**TRANSMISSION CONTROL COVERS USED ON ALL
3,000, 4,000, 5,000, 8,000 and 16,000 SERIES TRANSMISSIONS**

Service gram

MICHIGAN SG-306B
Group Ref. No. 2300

SUBJECT: Clutch Inner & Outer Discs as used in 3000, 5000, 8000 & 16000 series transmissions. All Models of MICHIGAN Tractor Shovels, Dozers & Scrapers

FIGURE 2

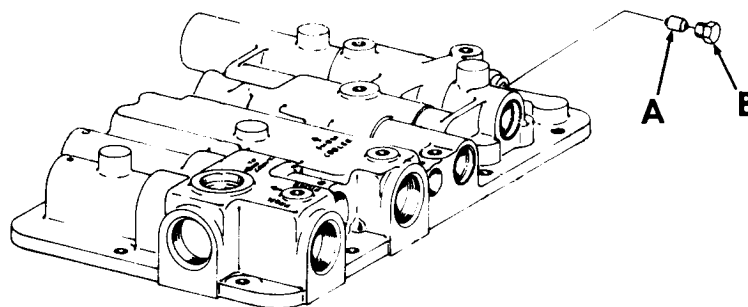
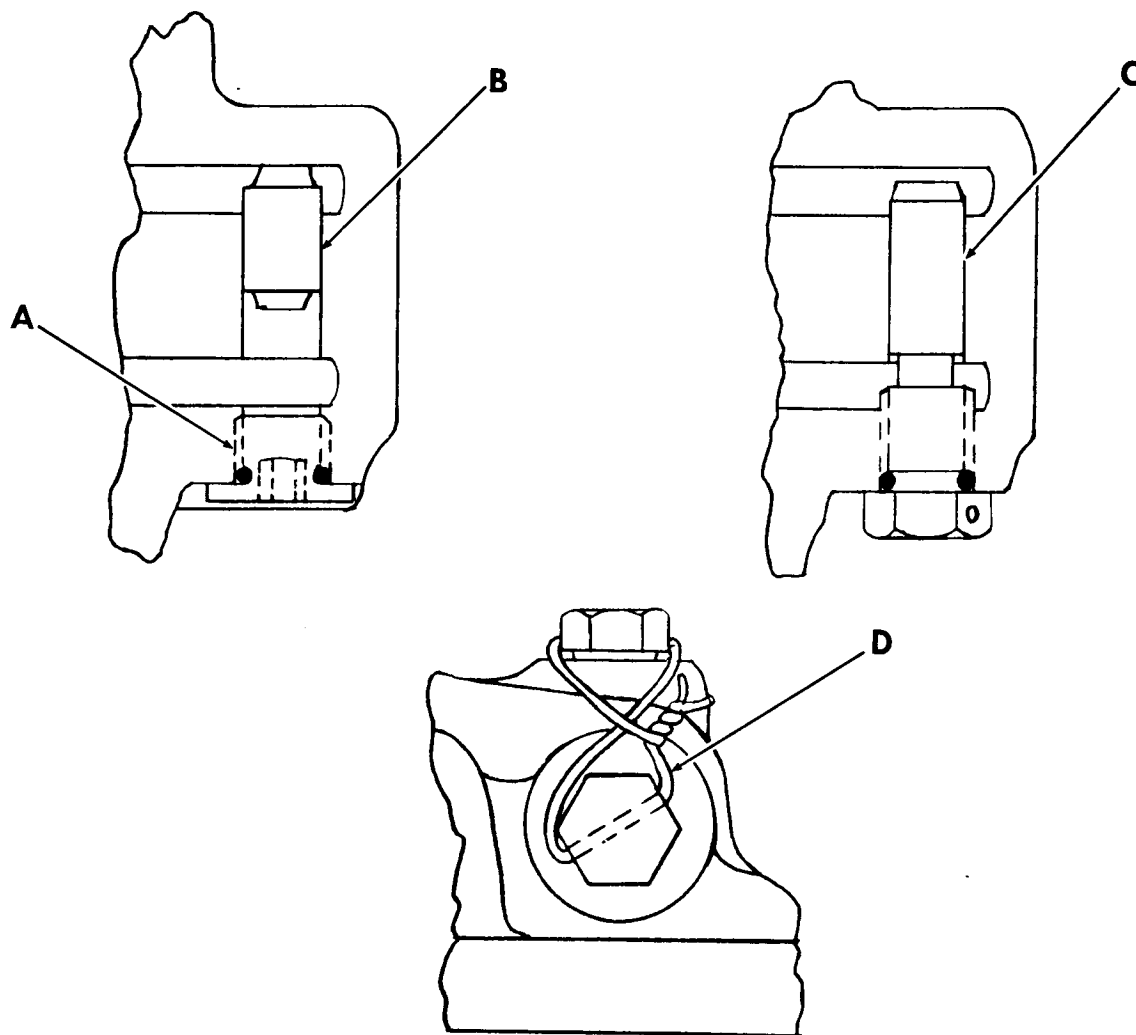
SUBJECT: Removal of Shuttle Valve from
Transmission Control Cover Assy.
Models 125-111A, 175-111, 175-111A, 175B,
275-111, 275-111A, 275B, 180-111, 280-111,
280-111A, LF280, 380-111, 380-111A,
475-111A, 110-H, 210-111, 210-H, 310-111,
310-H & 410

The shuttle valve used in control cover assemblies of transmissions used in the 100, 200, 300 & 400 Series machine models, as listed above, has been discontinued and removed since it served no useful function in these units. See Fig. 1 for typical location of shuttle valve and plug in the control cover assemblies.

The machining of the control cover casting has been changed to eliminate the cross-drilled hole for the shuttle valve and plug. On exsistant units in the field, however, whenever servicing a transmission or control cover assembly for any reason, on the above models, the shuttle valve and plug, where exsistant, should be removed and replaced with a plug assembly as outlined below.

INSTRUCTION (See Fig. 2):

1. Remove 47K-3 plug.
2. Using a magnet, remove shuttle valve (217654 for 100 & 200 Series machines and 217684 for 300 & 400 Series machines).
3. Install plug assembly - 232464 for 100 & 200 Series machines and 232975 for 300 & 400 Series machines. Both plug assemblies include 91F-3 o-ring.
4. Tighten plug assembly to 15-25 ft. lbs. torque (2,1-3,5 kgm) and install lockwire thru hole in plug and around plug in top of cover as shown in Fig. 2.

- A - 47K-3 Plug
- B - 217654 Shuttle Valve - 100 & 200 Series Machines
217684 Shuttle Valve - 300 & 400 Series Machines
- C - 232464 Plug Assy - 100 & 200 Series Machines
232975 Plug Assy - 300 & 400 Series Machines
- D - Lockwire As Shown

Figure 1

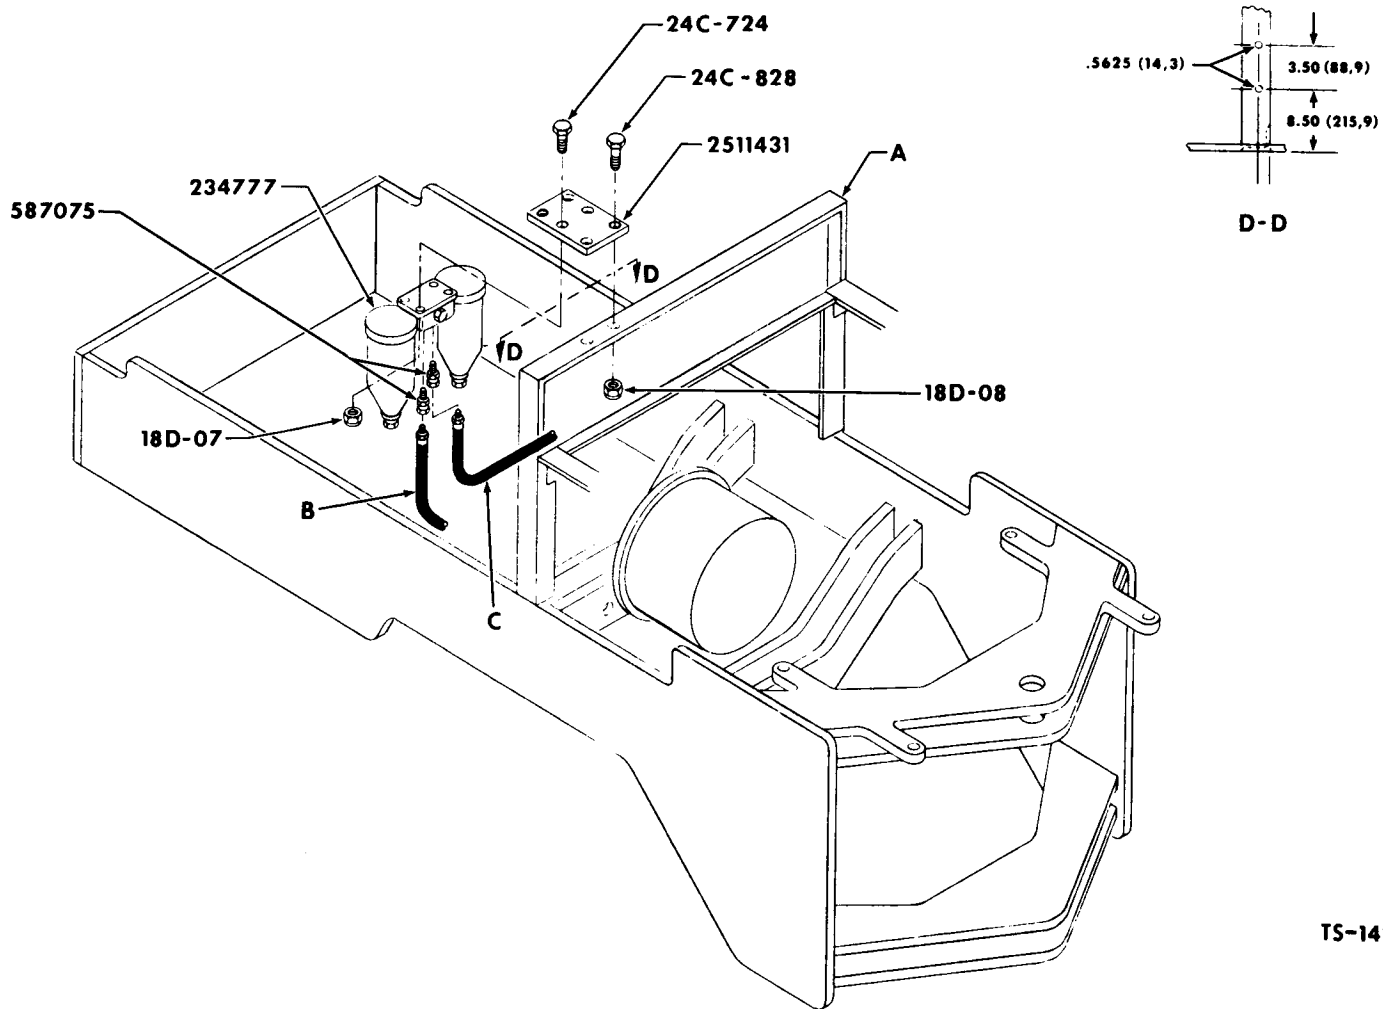
SUBJECT: Transmission & Converter Filter Assembly
Model 175B Tractor Shovel

An improvement change has been made on subject model machines featuring the use of a new, improved, heavy duty, dual element filter assembly in place of the previously used single element transmission and converter filter assembly. This change became effective on Model 175B Tractor Shovels shipped from the factory with serial numbers 427C101 and after for G. M. powered machines and 438C101 and after for Cummins powered machines.

1. Remove existing transmission filter assembly and bracket.
2. Refer to Figure 1 and drill two .5625 (14,3) diameter holes in the upper support angle according to dimensions shown.
3. Install 2511431 Mounting Bracket on upper support angle as shown using two 24C-828 Bolts and two 18D-08 Locknuts.
4. Install 234777 Filter Assembly on mounting bracket as shown using four 24C-724 Bolts and four 18D-07 Locknuts.
5. Connect existing hoses to filter assembly as shown using two 587075 Adapter Unions.

- A - Upper Support Angle
- B - Inlet Hose from Pump
- C - Outlet Hose to Trans.

TRANSMISSION SHAFT IDENTIFICATION

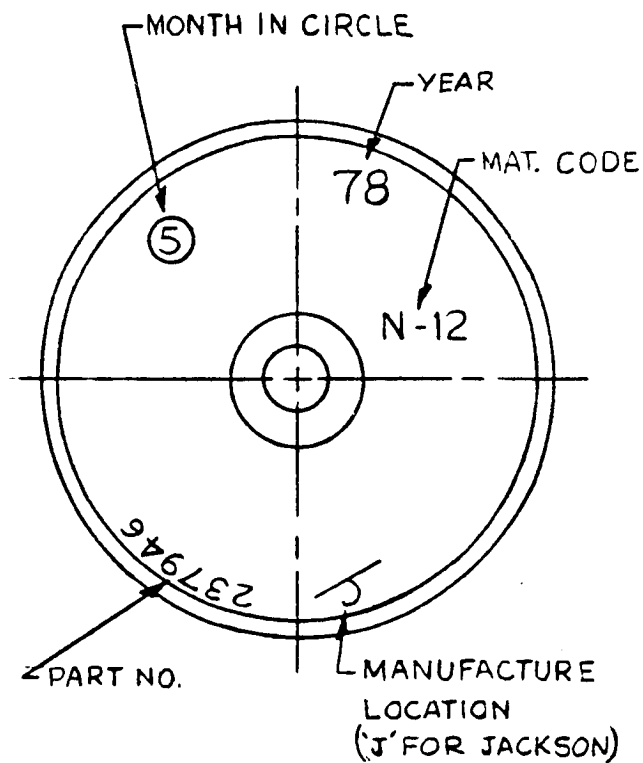
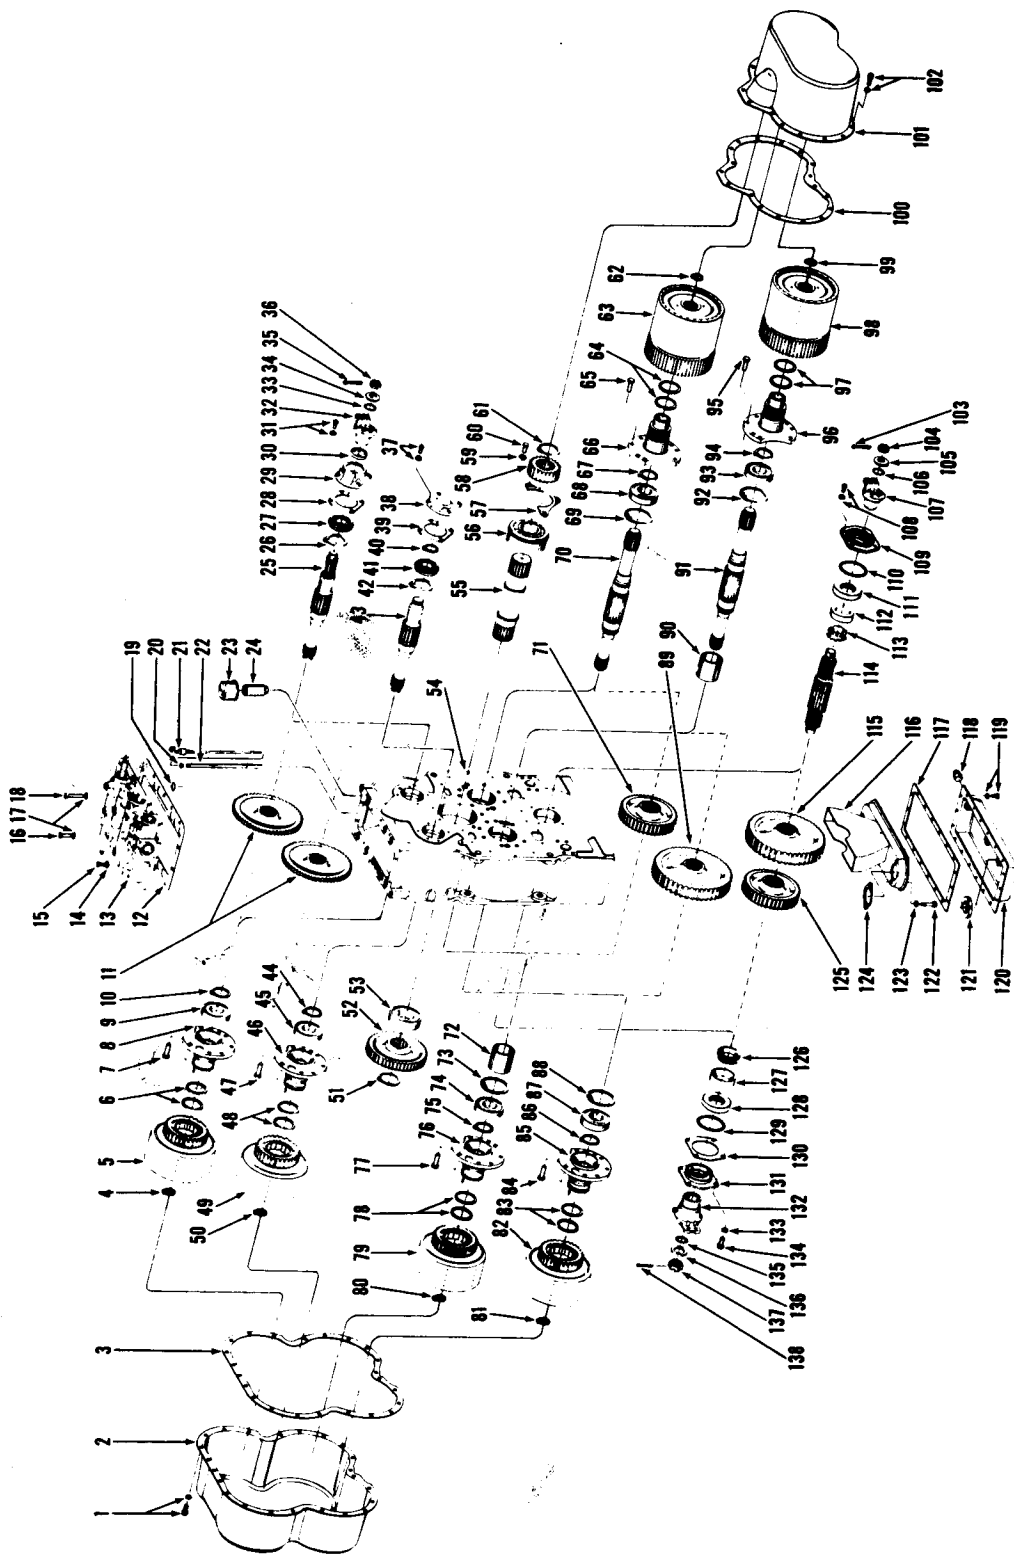
SUBJECT: Transmission Input and Reverse Shaft Revision
Model 4421 Transmission Assembly with serial numbers before 84026XJ

Input and reverse shafts made of different material are now available for machines with serial numbers listed above.

The new shafts are stronger for better reliability.

The new input shaft part number is 238550, which replaces part number 237946.

The new reverse shaft part number is 238551, which replaces part number 237947.

See Figure 1 for correct shaft identity.

7. Check the input and reverse shafts. See Figure 1 for correct identification. If one or both shafts have the suspect code, replace both of them at this time.

SUSPECT SHAFTS

GOOD SHAFTS

FIGURE 5

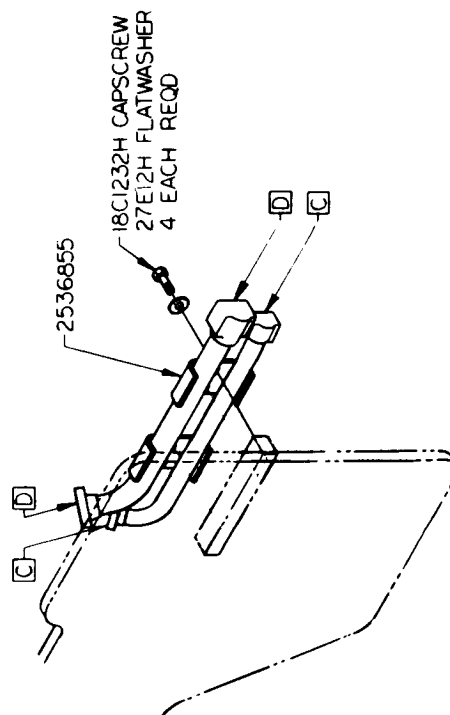
PIVOT PLATE REWORK

IF BUCKET SUPPLY TUBES
ARE MOUNTED AS SHOWN
ABOVE LEFT, REMOUNT
THEM AS ABOVE RIGHT

NOTE: LUBRICATE O RINGS WITH GREASE BEFORE INSTALLING

Figure 10

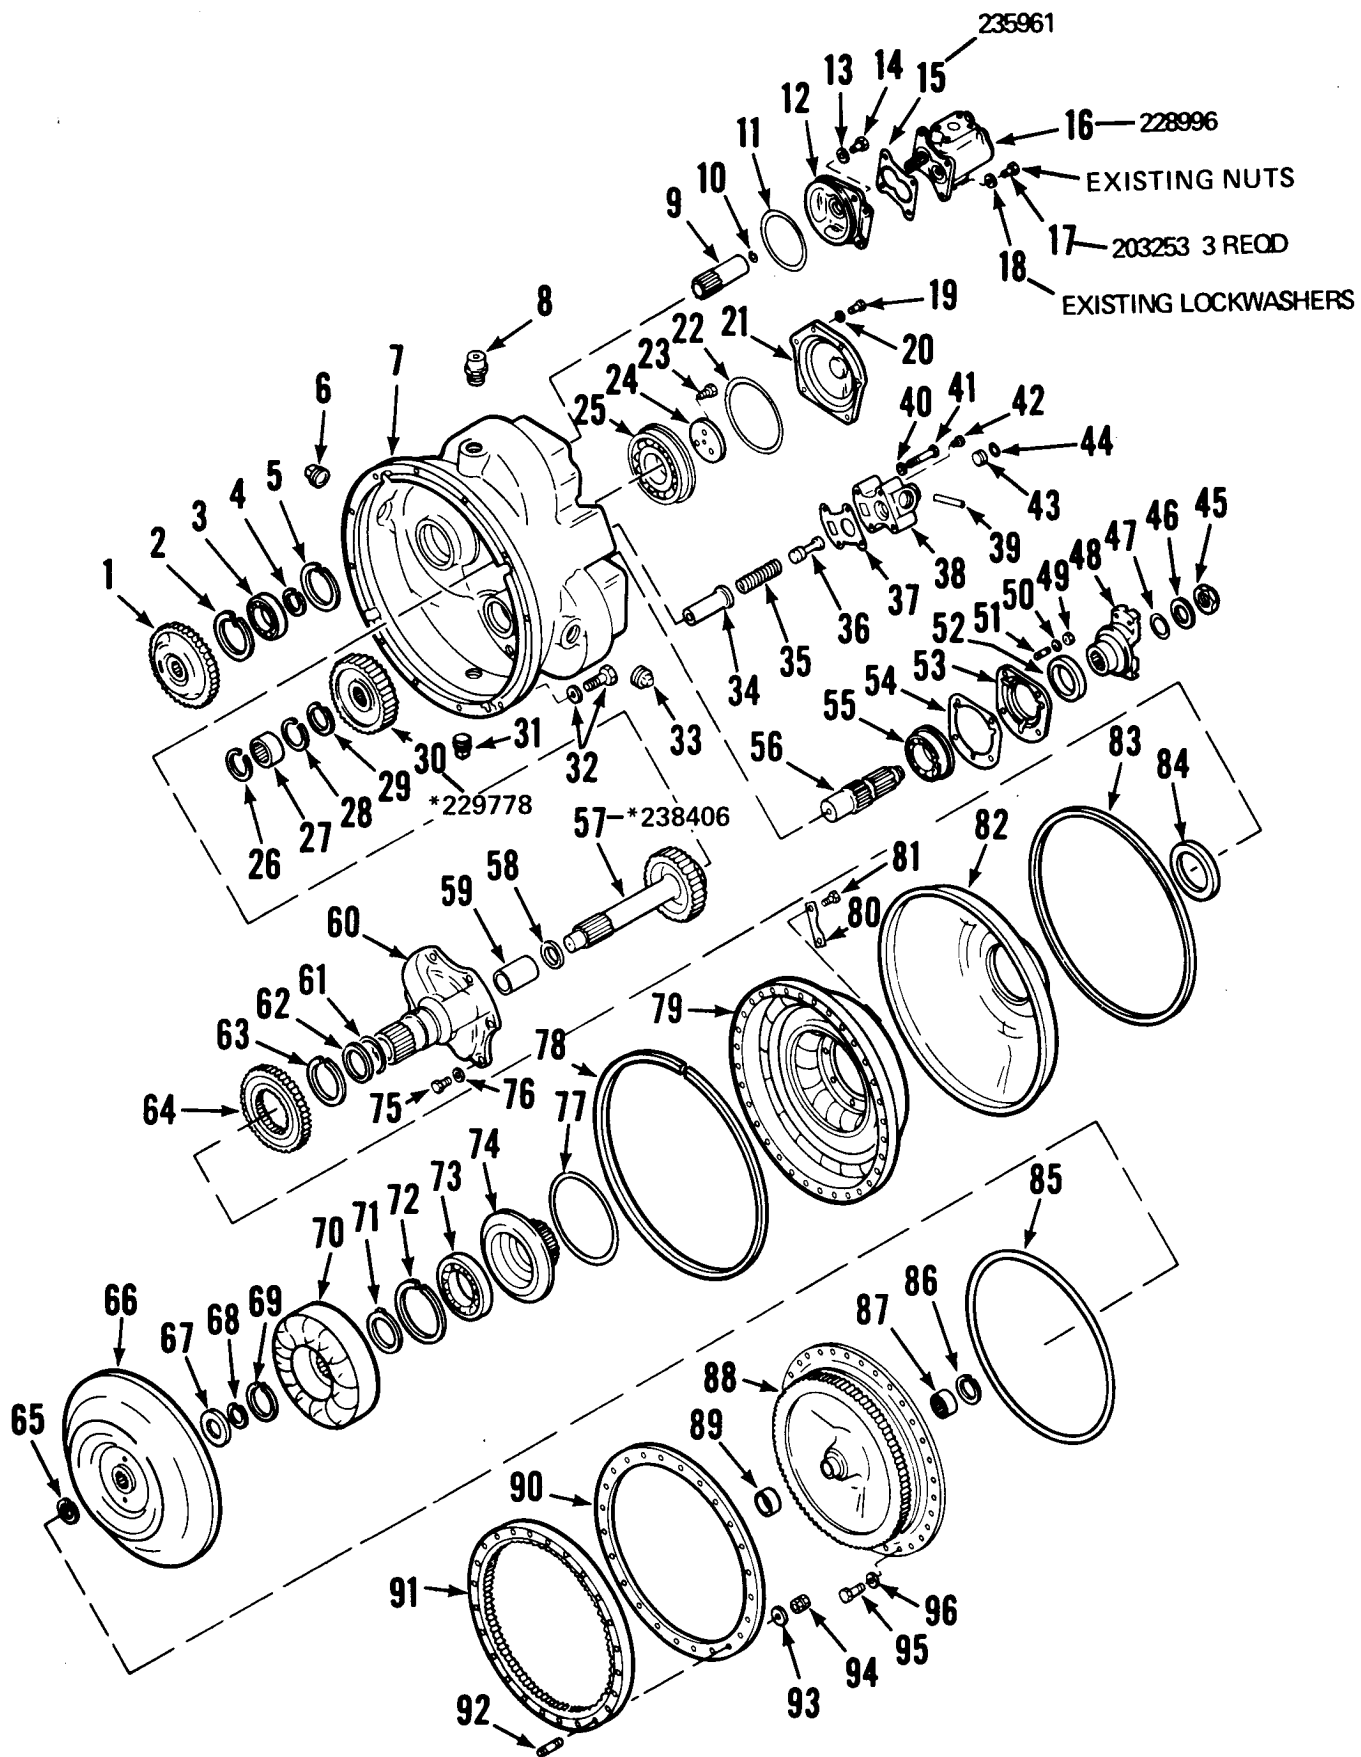
*New parts to be installed on machines using 29 .5-25 tires ONLY.
See Step 11 of installation instructions.

20. If the converter was removed for rework (See Step 11) install it at this time. Remove the existing nuts, lockwashers, studs, converter charging pump and gasket from the converter. See Figure 10 and install 1 - new 235961 Gasket, 1 - new 228996 Converter Charging Pump, 3 - new 203253 Studs, existing lockwashers and nuts onto the converter assembly. Discard the existing converter charging pump, gasket and studs.
